Request for Additional Information: Section 117(3) of the Maritime Area Planning Act 2021

Re: Uisce Eireann Maritime Usage Licence Application Reference: MUL230015

Image 1 and 2: Source: Tailte Eireann Map Genie Premium ITM mapping

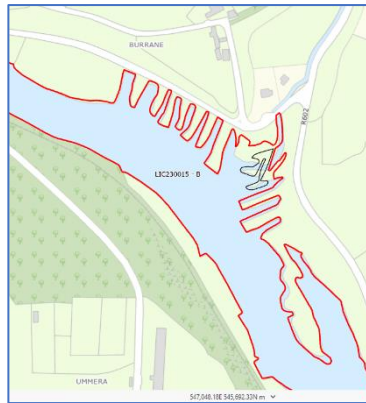
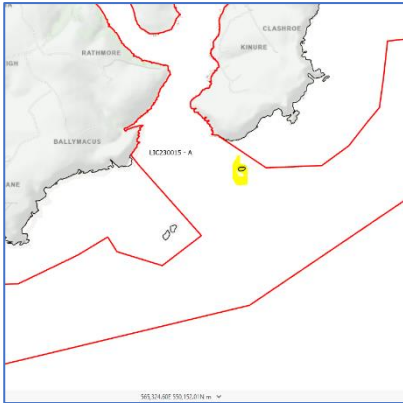
- a. Map the proposed MUL areas using the digital High Water Mark, excluding all islands (see images 1 and 2) and terrestrial land (see images 3 and 4)
